CITY OF VALDEZ
Project Title: Lowe River Dike Renovation – Phase I
Project No.: 13-310-8060
Contract No.: 1122

SUBJECT: Addendum No.1

This four (4) page Addendum makes the following changes and/or clarifications:

G2

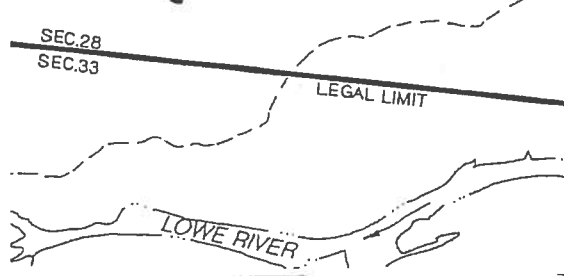
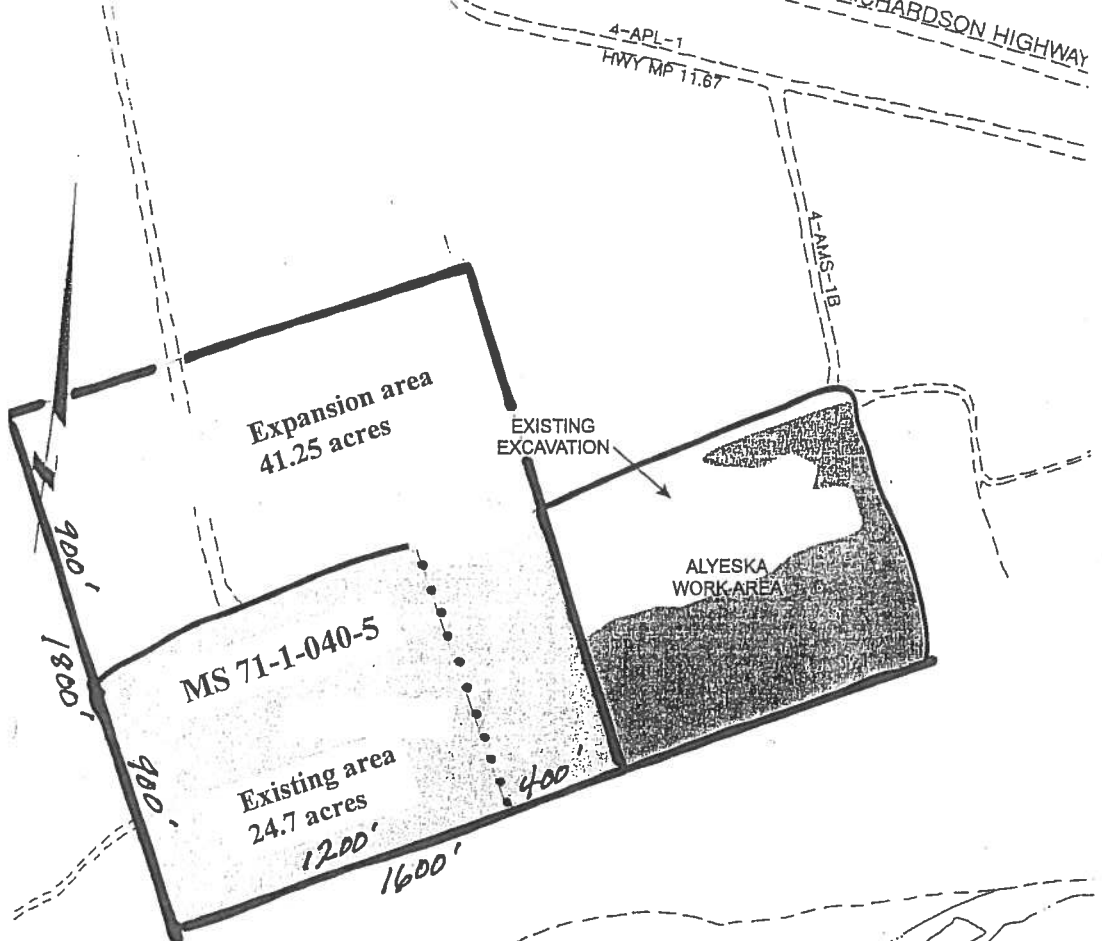
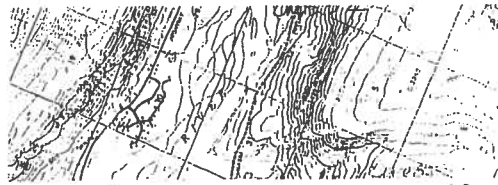
1. Replace sheet G2 with revised sheet G2 dated 8/8/13 attached to this document.
2. The contractor will provide truck counts for the material hauled out of the MP 12 pit.
